**PETITION FOR TEXT AMENDMENT, MAP TEXT AMENDMENT,
SUBDIVISION APPROVAL, AND SITE PLAN APPROVAL OF
SADDLE RIDGE DEVELOPERS FOR PROPERTY LOCATED AT
SPORT HILL ROAD, SILVER HILL ROAD, CEDAR HILL ROAD,
AND WESTPORT ROAD (ROUTE 136)**

EASTON CROSSING

**Supplemental Materials
November 3, 2014**

**RESPONSE TO LETTER FROM EASTON BUILDING OFFICIAL
DATED SEPTEMBER 16, 2014**

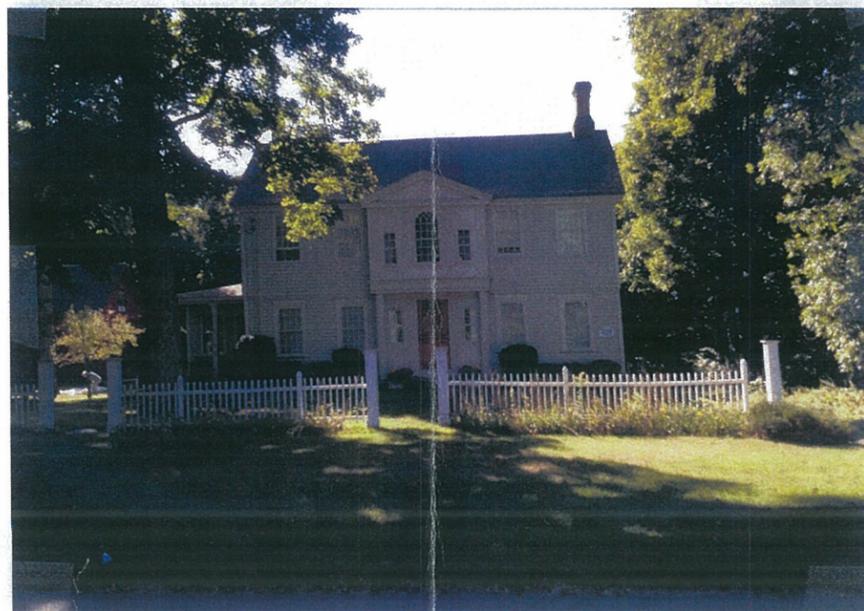
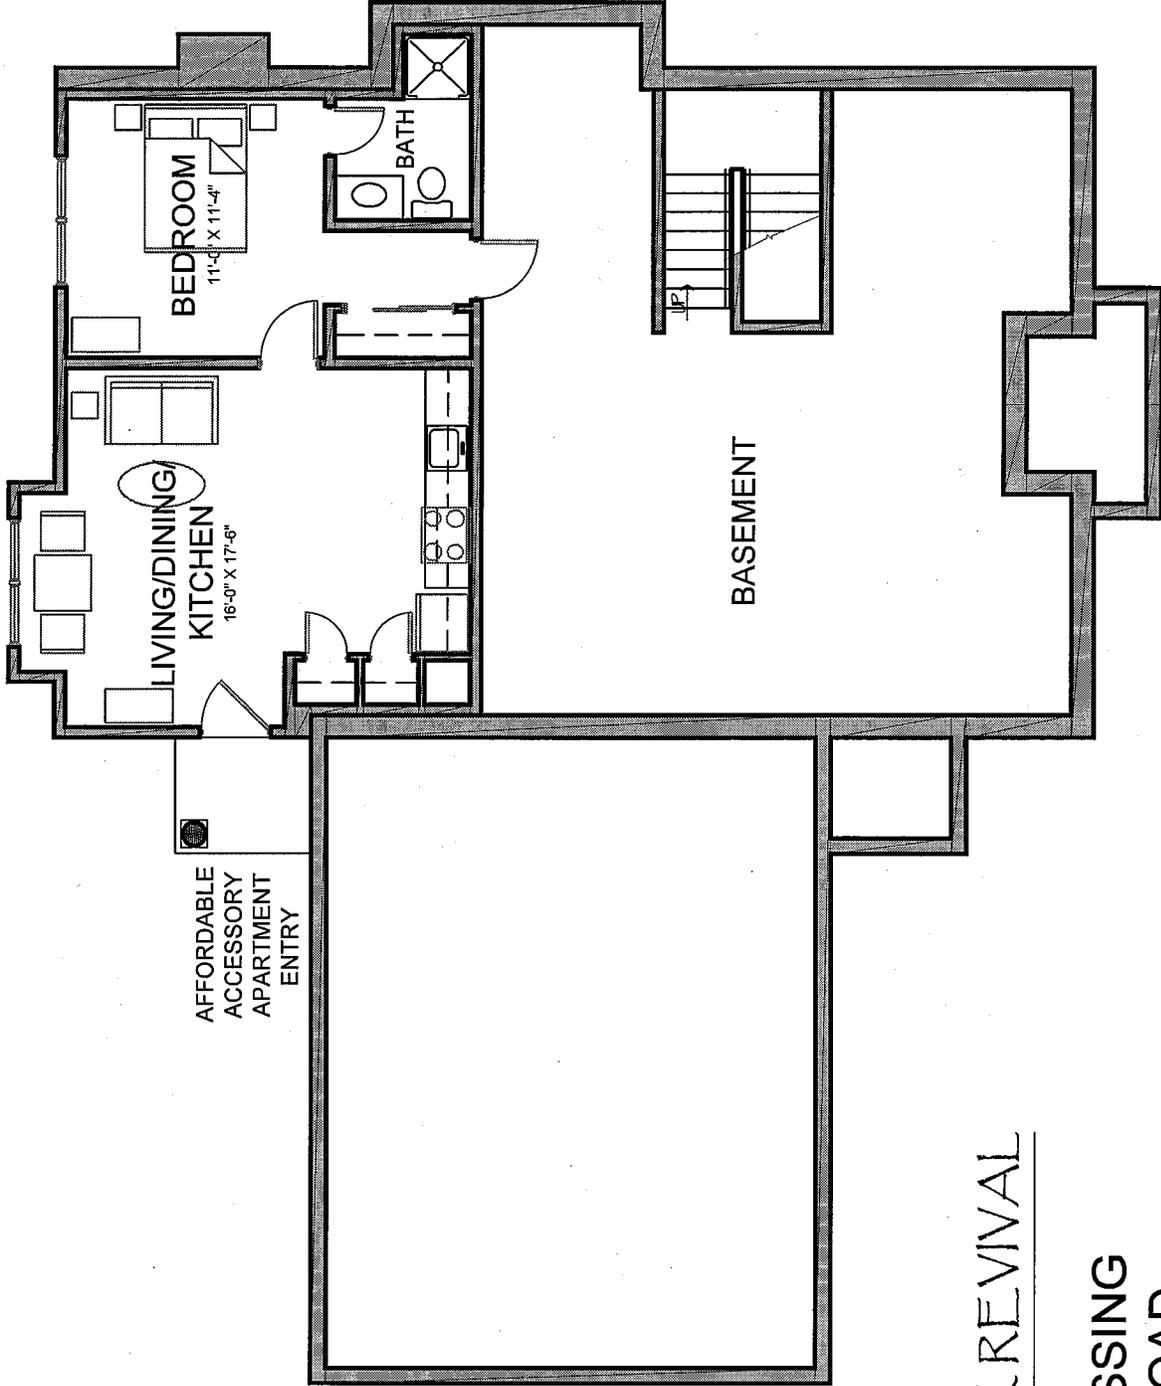
1. *Design for The Georgian is a four (4) bedroom three and one half bath (3 1/2) residence with a one bedroom one bath apartment over the garage. This is considered an accessory use as it is contiguous on the interior of the residence and can be used as single family dwelling.*

2. *Design for The Greek Revival is a four (4) bedroom three and one half bath (3 1/2) residence with a one bedroom one bath apartment in a lower level walk out at the rear of the building. This is considered a two (2) family dwelling because it is completely separate from the residence and could not be used as a single family residence.*

RESPONSE: Comment noted.
